December 9, 2005
L-05-192

**Subject: Beaver Valley Power Station, Unit Nos. 1 and 2
BV-1 Docket No. 50-334, License No. DPR-66
BV-2 Docket No. 50-412, License No. NPF-73
Supplemental PRA Information in Support of License Amendment
Request Nos. 302 and 173, Extended Power Uprate (EPU)**

Updated Responses to Address Questions 2.c and 2.d of RAI dated August 2, 2005

Figure 2-1: MAAP Pressurizer Water Level for Case SBO11

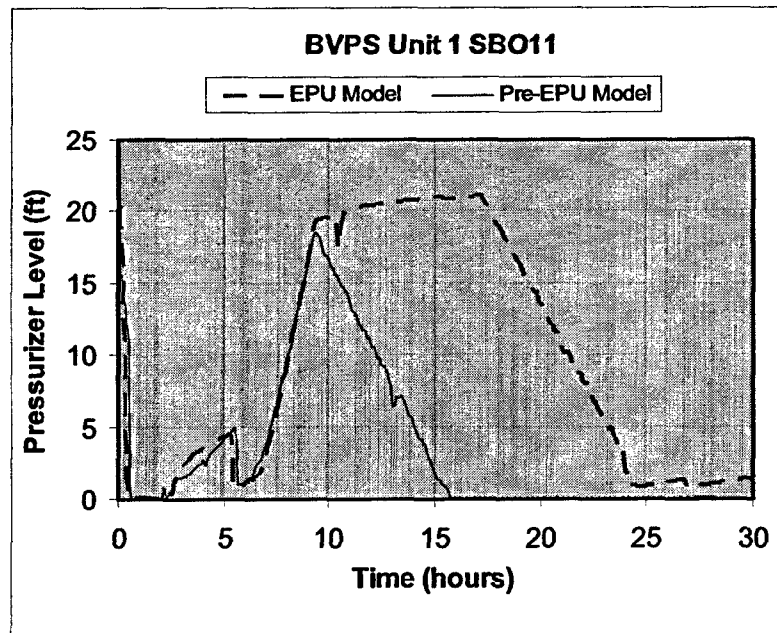
Table 10.16-1 gives pre- and post-EPU times to core damage for station blackout scenarios. Why does this time increase on BVPS-1 and decrease on BVPS-2 for the "182 gpm, successful cooldown/depressurization, primary plant demineralized water storage tank make-up available" case?

Regarding the pressurizer water level, the pre-EPU model indicates that the pressurizer reaches a maximum level in about 9 hours and then drains until it is empty, which occurs in about 16 hours. The BVPS-1 post-EPU model indicates a sustained pressurizer level until approximately 17 hours (see Figure 2-1).
